### Addendum

SR 161  
JOVITA BLVD. TO SR 18  
WIDEN - STAGE 1  
STPF-1009(002) & STATE

**Addendum No. 3**

**Addendum No. 1**

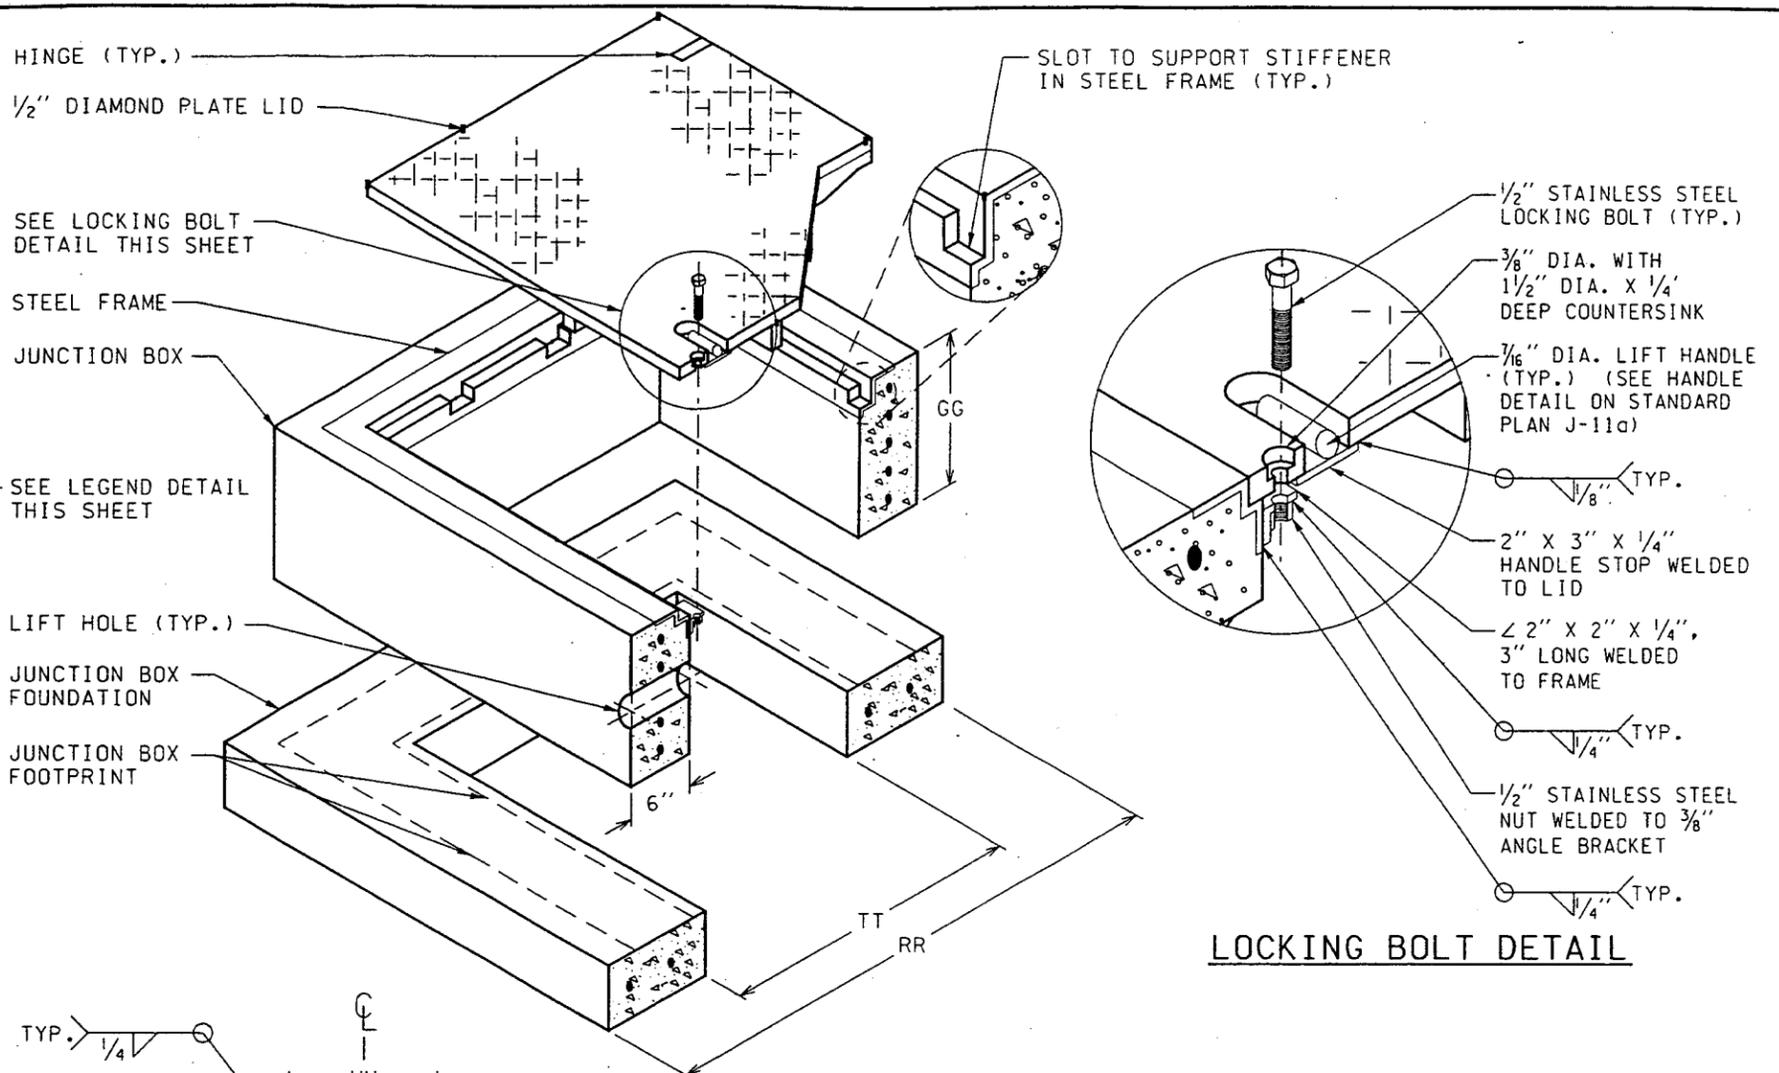
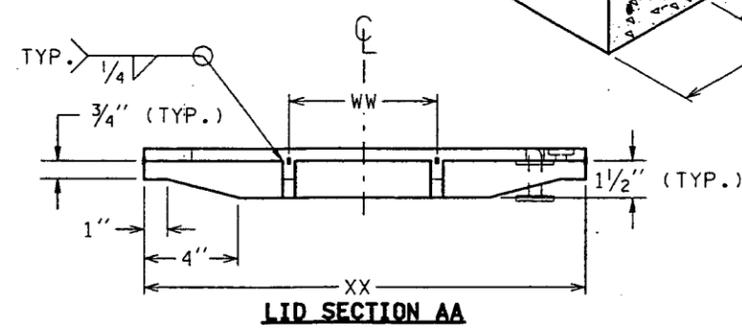
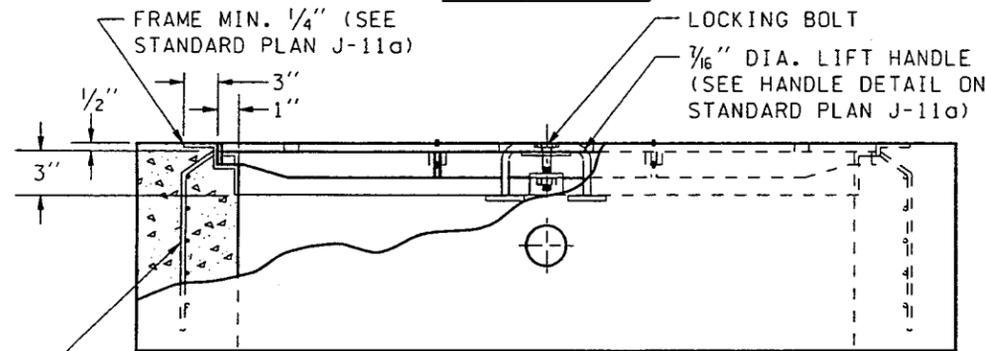
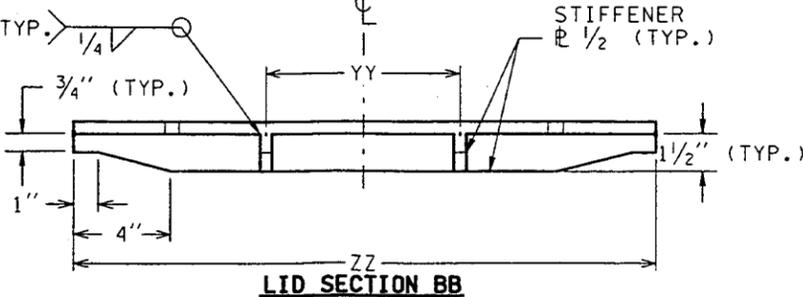
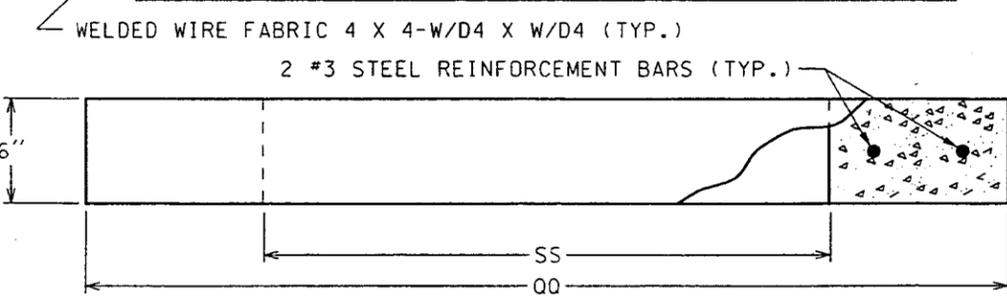
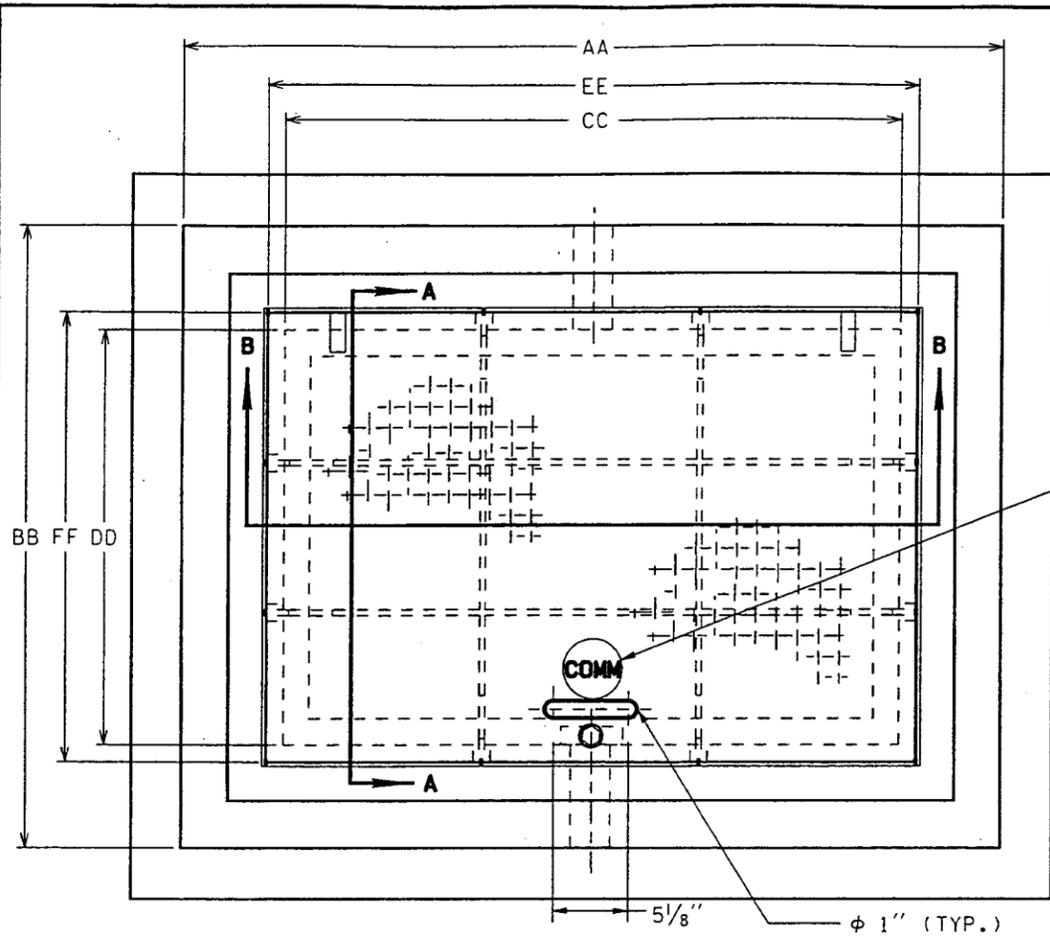
1. Plan sheets 1, 5, 11, 12, 14, 16, 78, 79, of 104 are revised as shaded and noted on the attached sheets.
2. Plan sheets 17A, 17B, and 79A are new sheets.

NOTE: MODIFIED JUNCTION BOXES SHALL MEET ALL SPECIFICATIONS ON STANDARD PLAN J-11a WITH THE EXCEPTION THAT THE BOX DEPTH, WALL THICKNESS, FOUNDATION DIMENSIONS, STEEL REINFORCEMENT AND LIDS SHOULD BE AS SHOWN ON THIS DETAIL. THE HINGES SHALL ALLOW THE LID TO OPEN 180°.

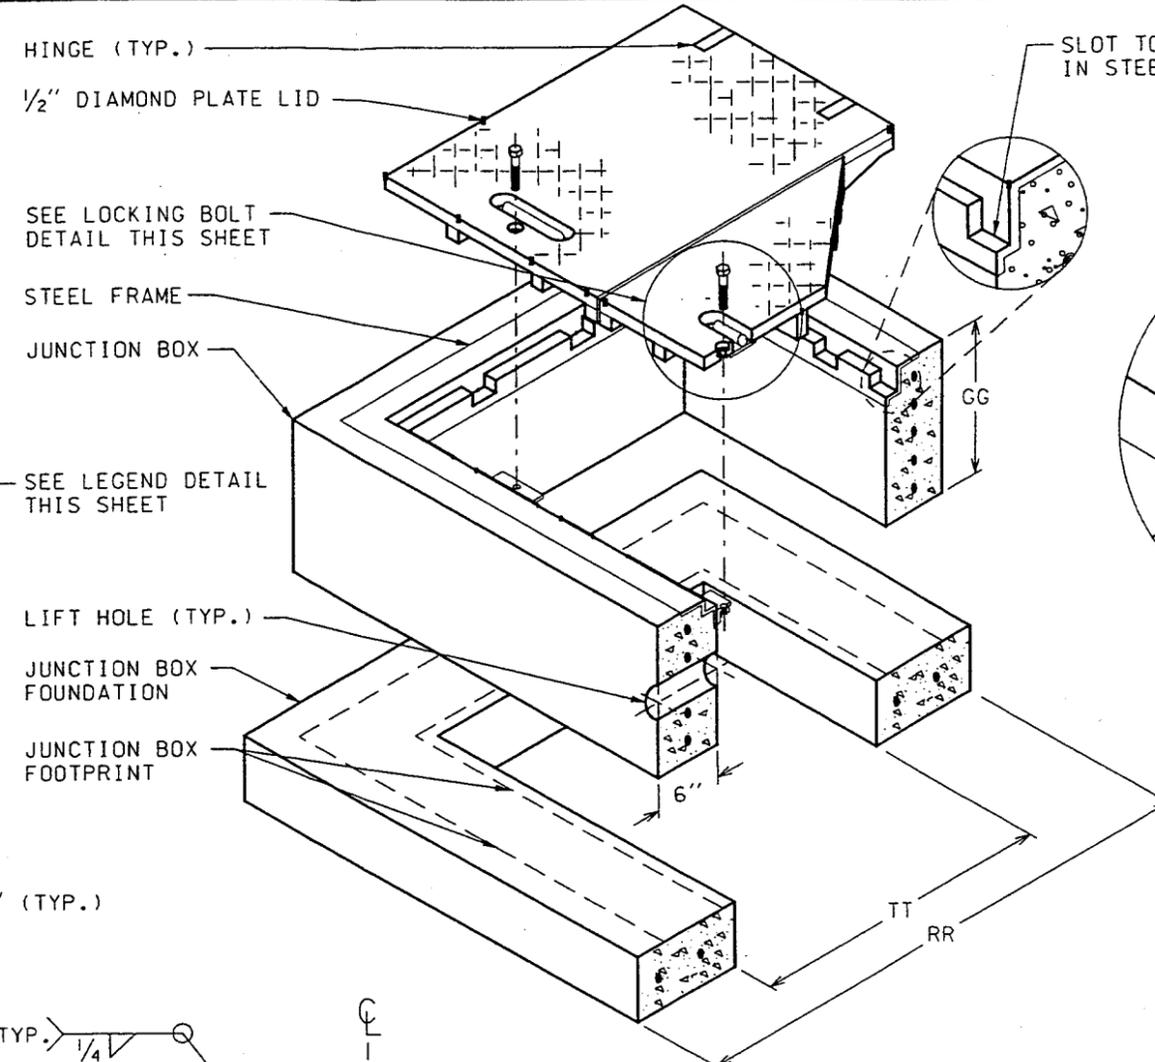
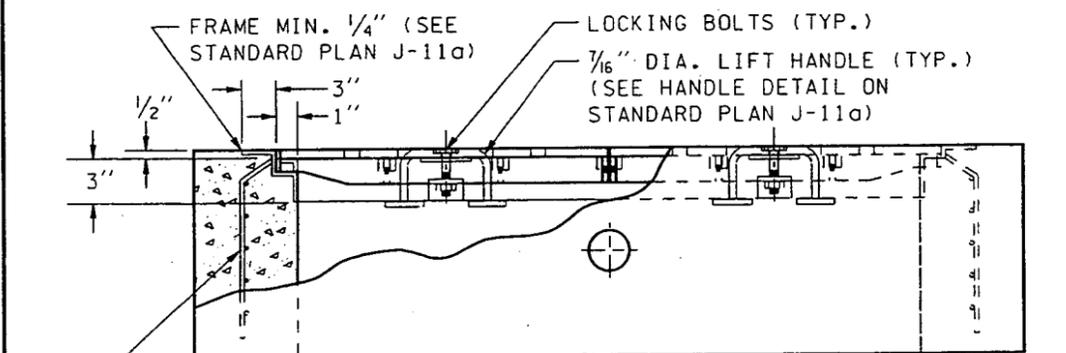
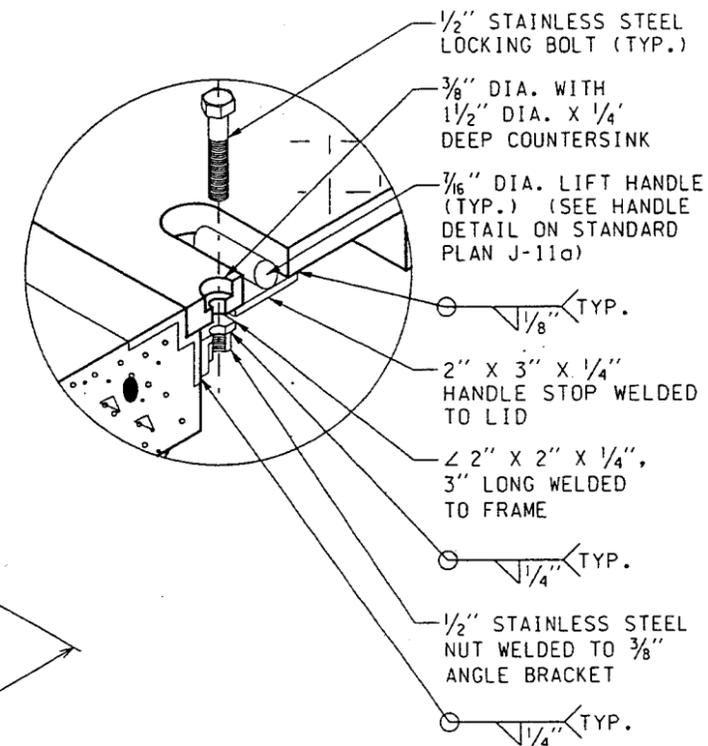
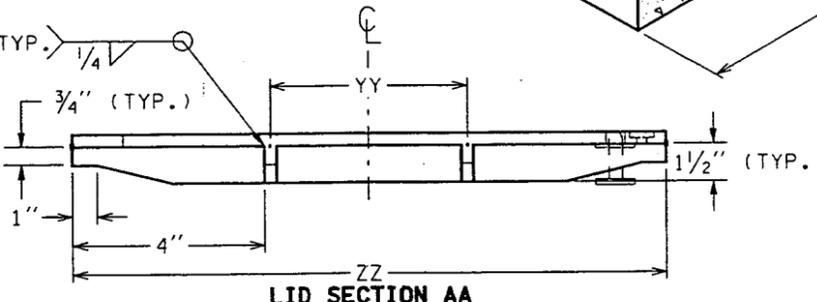
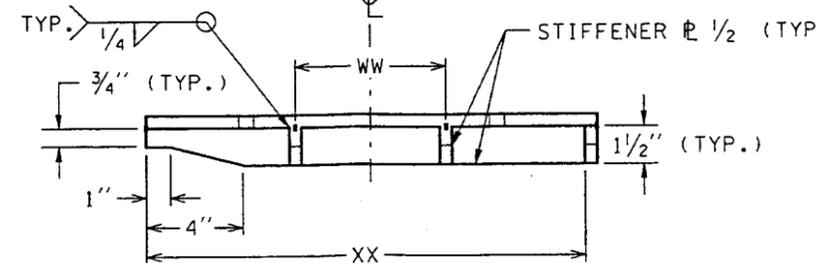
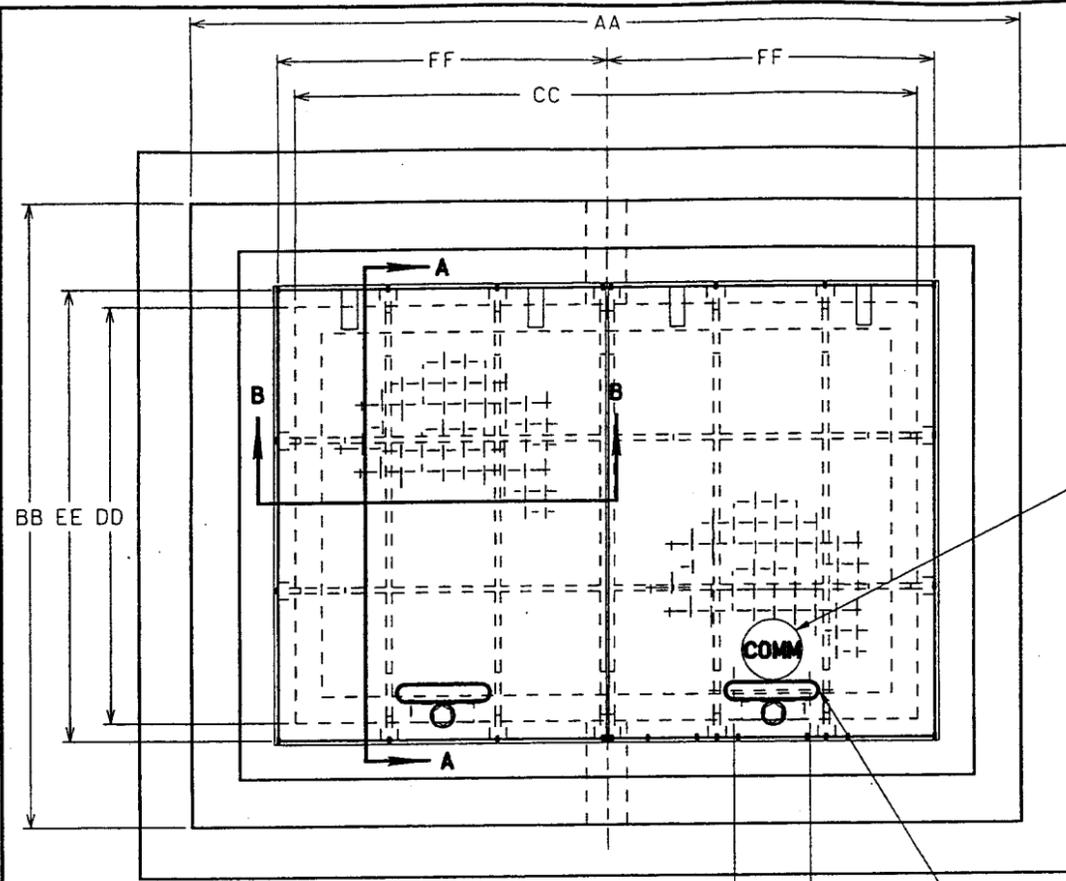
NOTE: MODIFIED JUNCTION BOXES SHALL MEET ALL SPECIFICATIONS ON STANDARD PLAN J-11a WITH THE EXCEPTION THAT THE BOX DEPTH, WALL THICKNESS, FOUNDATION DIMENSIONS, STEEL REINFORCEMENT AND LIDS SHALL BE AS SHOWN ON THIS DETAIL. THE HINGES SHALL ALLOW THE LIDS TO OPEN 180°.
